North Campus Faculty Housing Phase II  
Project No. FM110407L/986315

**Addendum No. 6**

ADDENDUM NUMBER 6  
to the  
CONSTRUCTION DOCUMENTS

TYPICAL SLAB SECTION

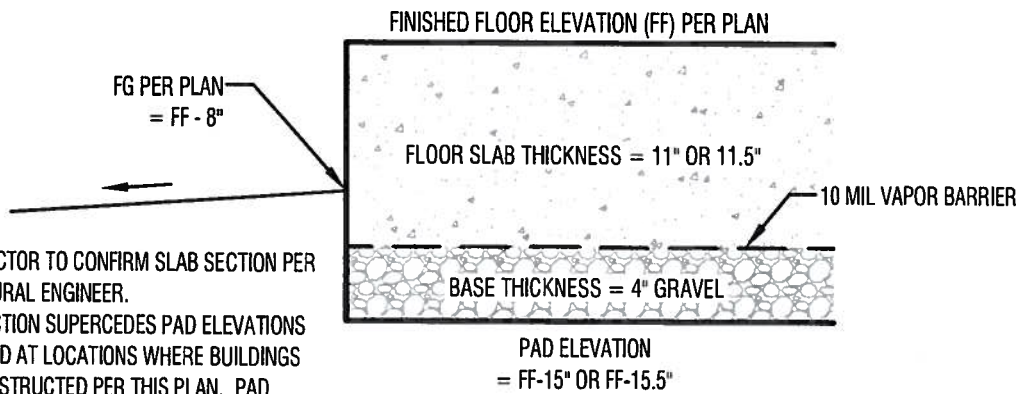
7. Pad and Finish Floor elevations, as relate to foundation details, are accomplished per the attached Sketch titled Addendum 6 Precise Grading Plan (Sht 1) of 1.

- NOTE:
1. CONTRACTOR TO CONFIRM SLAB SECTION PER STRUCTURAL ENGINEER.
  2. THIS SECTION SUPERCEDES PAD ELEVATIONS INDICATED AT LOCATIONS WHERE BUILDINGS ARE CONSTRUCTED PER THIS PLAN. PAD ELEVATIONS AT FUTURE BUILDING LOCATIONS REMAIN AS INDICATED PER PLAN.

**BUILDING 400A: SECTIONS**

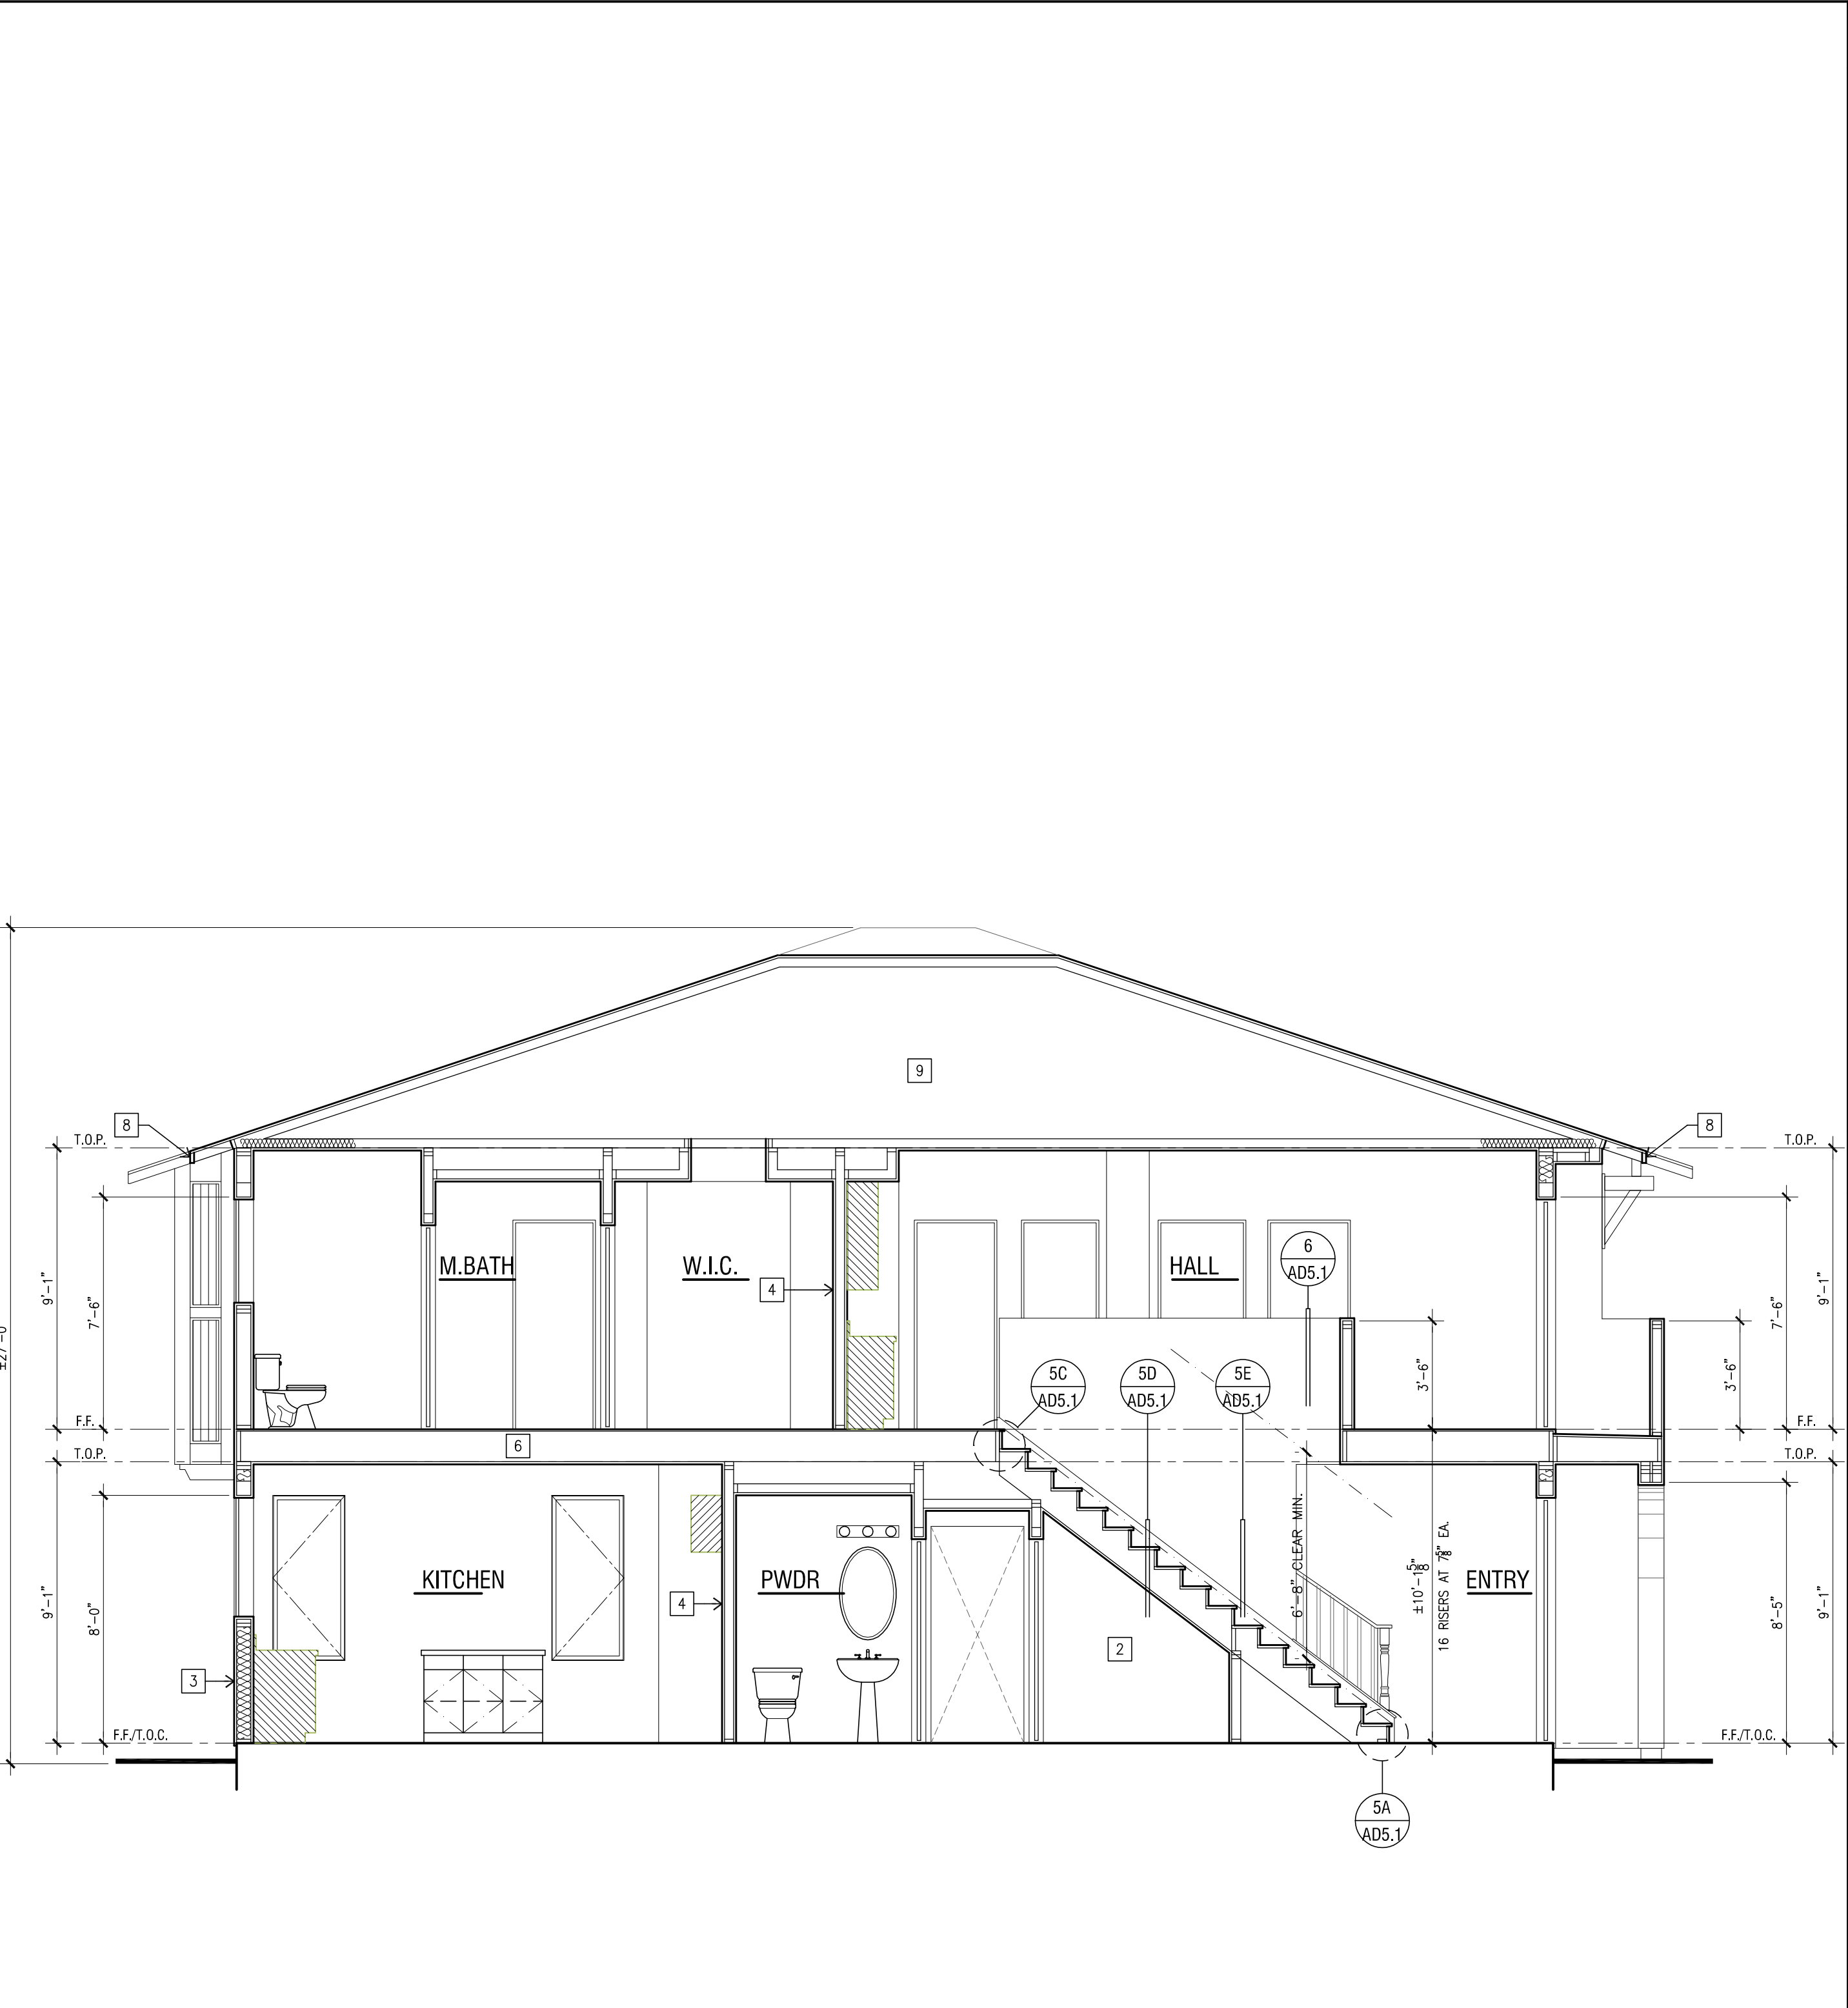
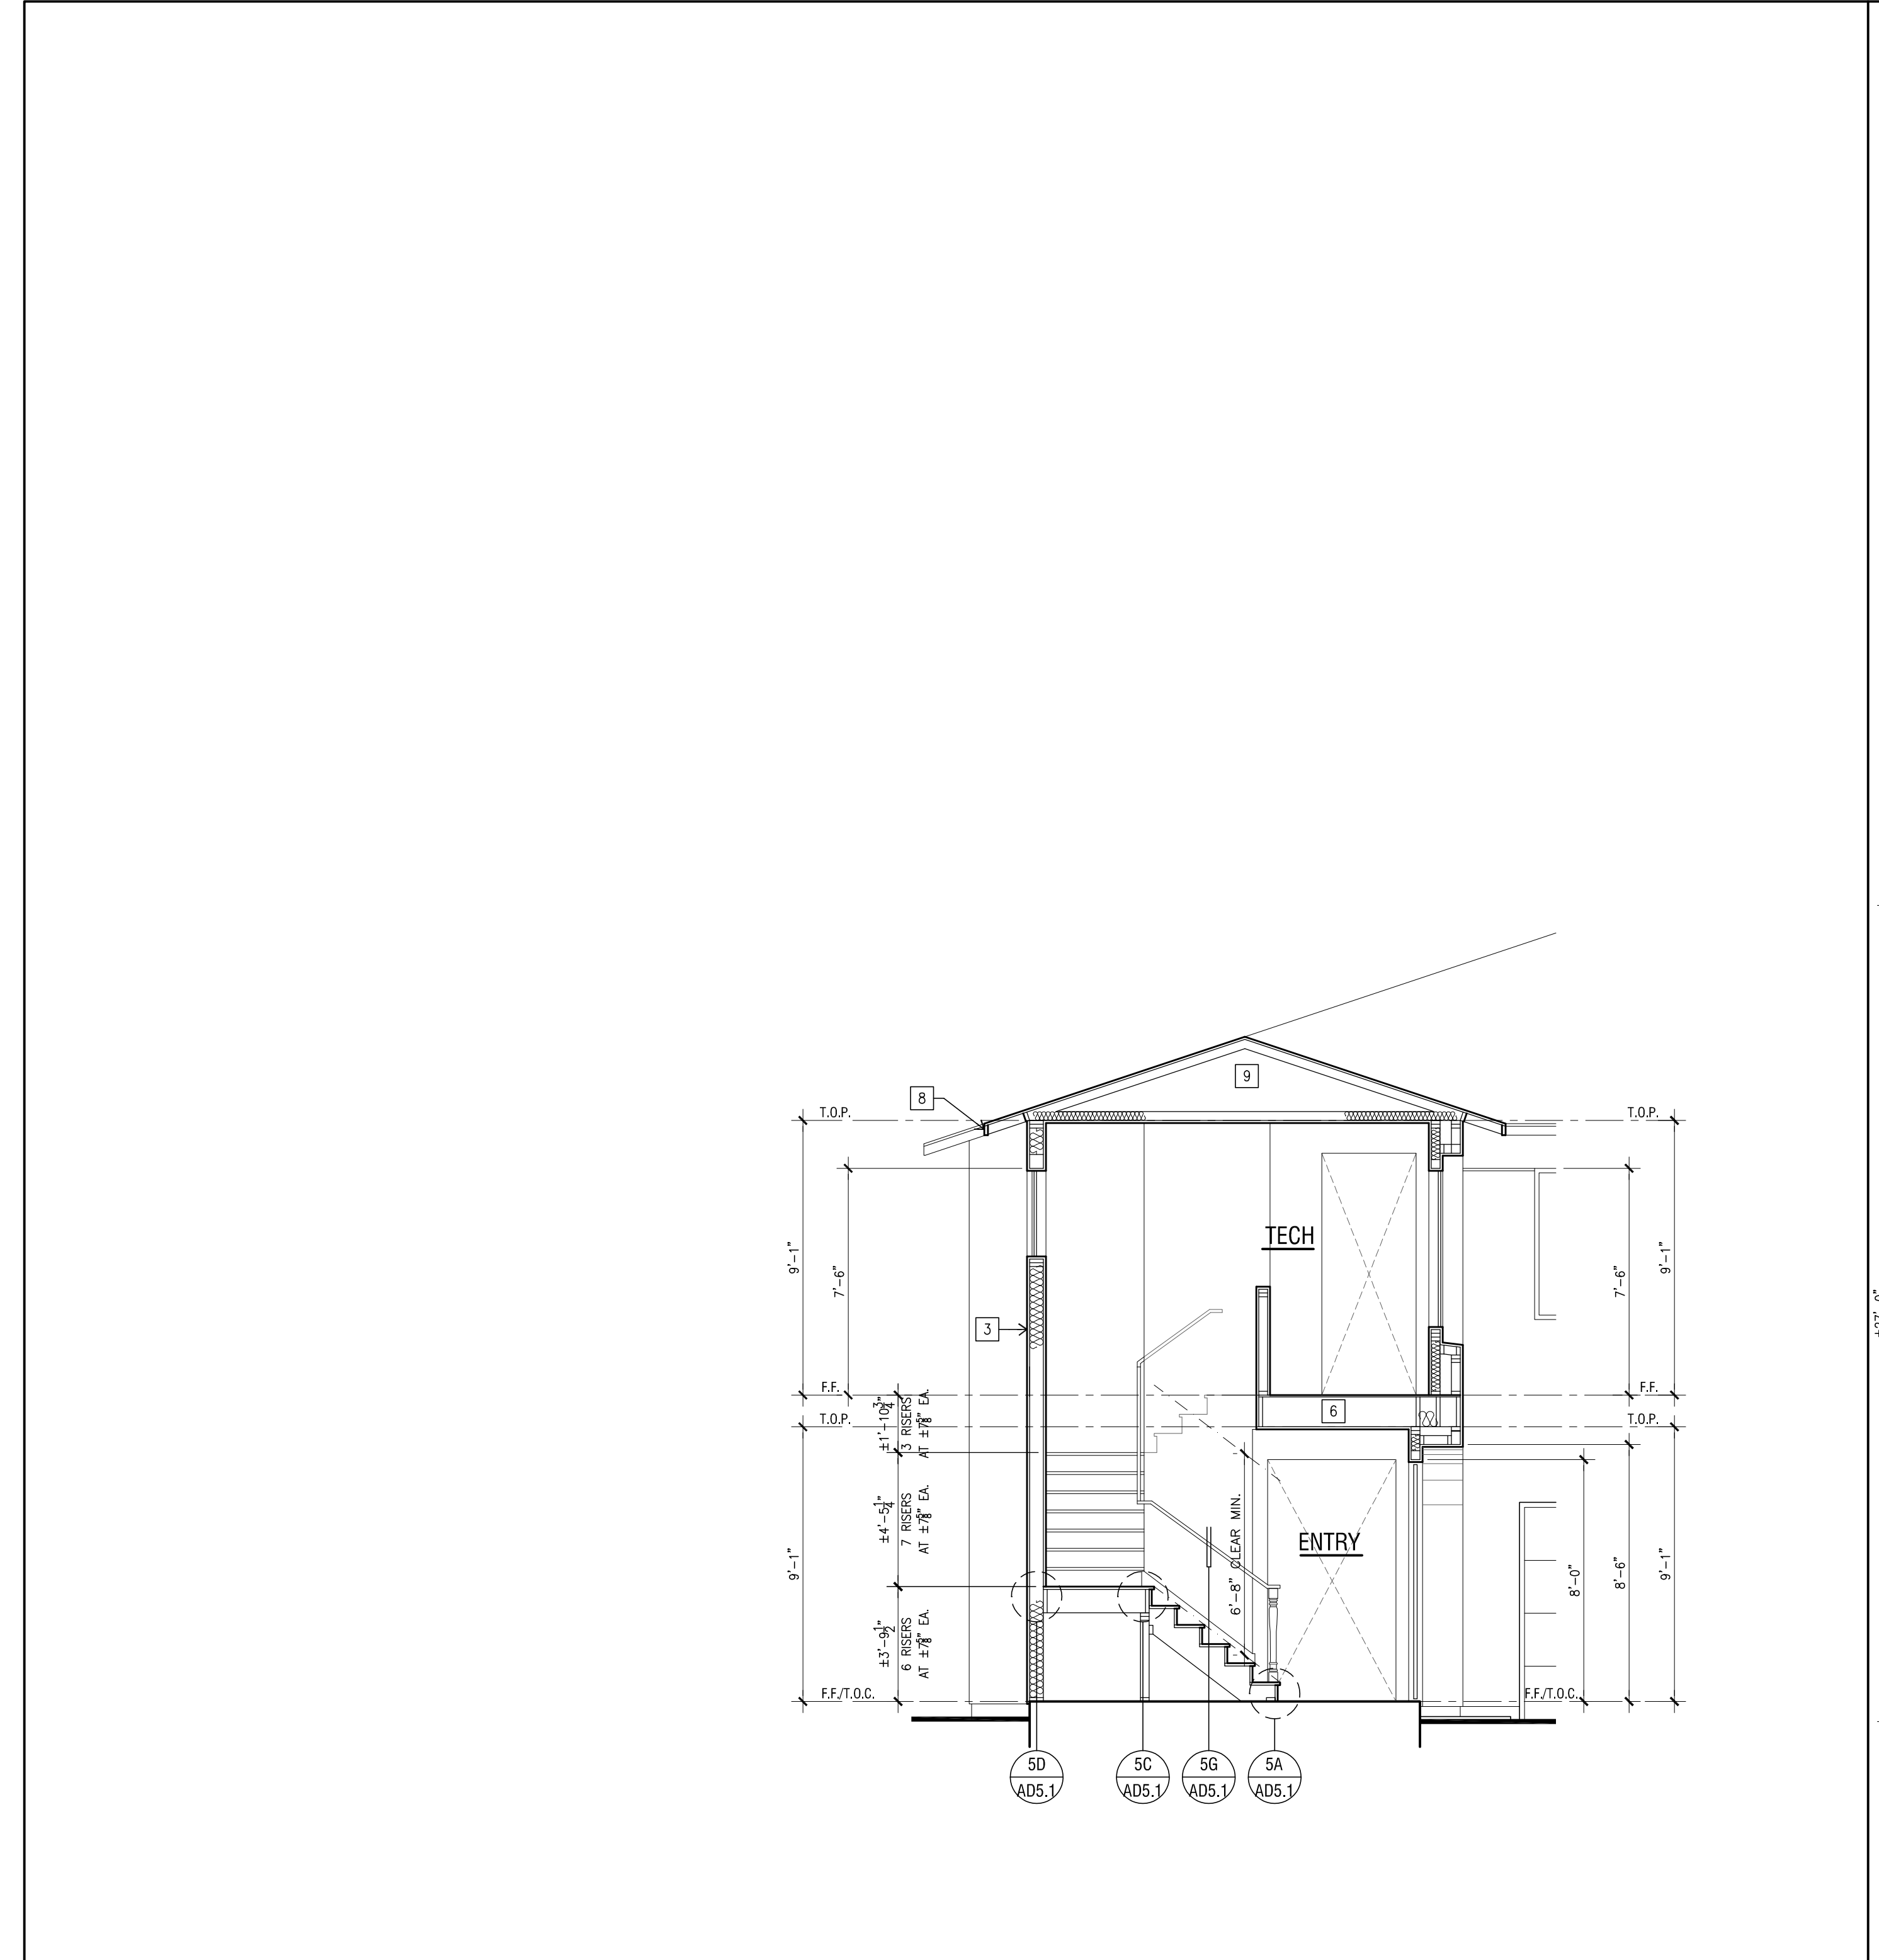
1. **Add** the attached Architect Sketches 1 of 8, dated 9/23/11.  
Sketch 1 of 8 Building 400A: Sections  
Sketch 2 of 8 Building 400B: Sections  
Sketch 3 of 8 Building 500B: Sections  
Sketch 4 of 8 Building 600A: Sections
